WCAP-16500-NP-A
Revision 0

CE 16x16 Next Generation Fuel Core Reference Report

| A | Letter from Ho K. Nieh (NRC) to J. A. Gresham (Westinghouse), "Final Safety Evaluation for Westinghouse Electric Company (Westinghouse) Topical Report (TR) WCAP-16500-P, Revision 0, 'CE [Combustion Engineering] 16x16 Next Generation Fuel [(NGF)] Core Reference Report' (TAC NO. MD0560)," July 30, 2007. |

Figure 2-14
Typical 16 CE NGF Fuel Rod Design (Plant B)

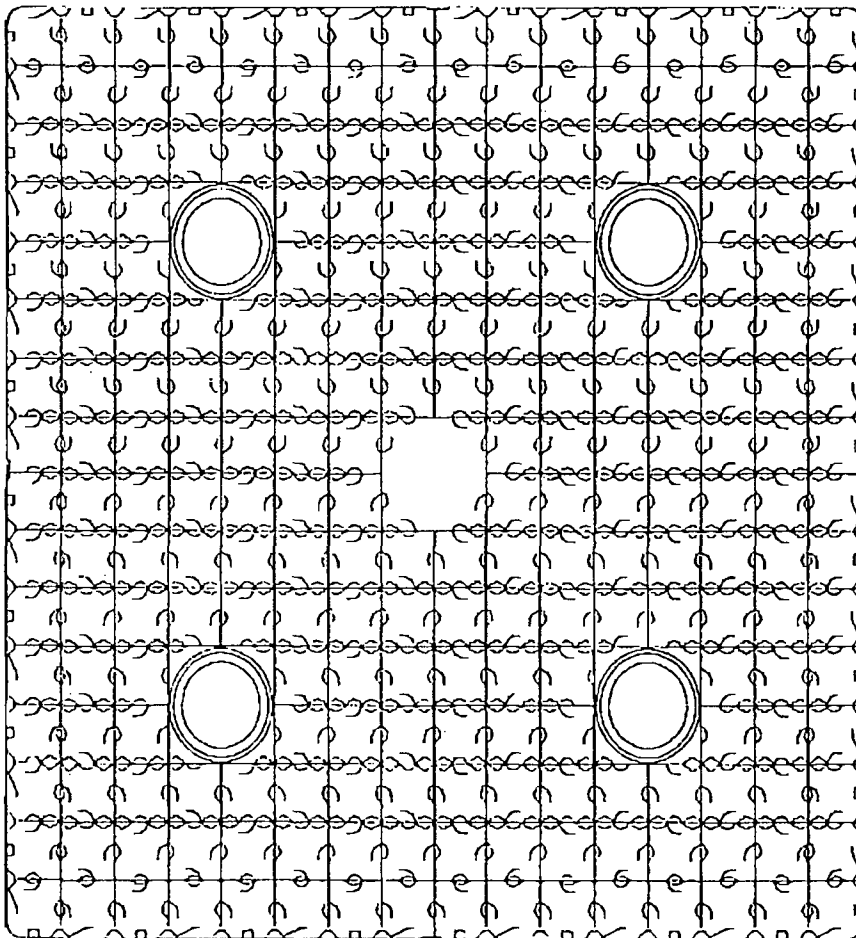
Section 2.5 of TR WCAP-16500-P describes the fuel rod mechanical design basis and evaluations. Figure 2-14 of TR WCAP-16500-P illustrates changes in the fuel rod design relative to the standard CE 16x16 design.

Evaluations have been done to verify that the current licensed fuel rod bases and design criteria can be met for the CE 16x16 NGF design. The CE 16x16 NGF fuel rod design (Figure 2-14) has been evaluated using the NRC-approved Westinghouse fuel rod performance code ⁽¹⁴⁾⁽¹⁵⁾⁽¹⁶⁾. The fuel rod design bases and criteria are described below.
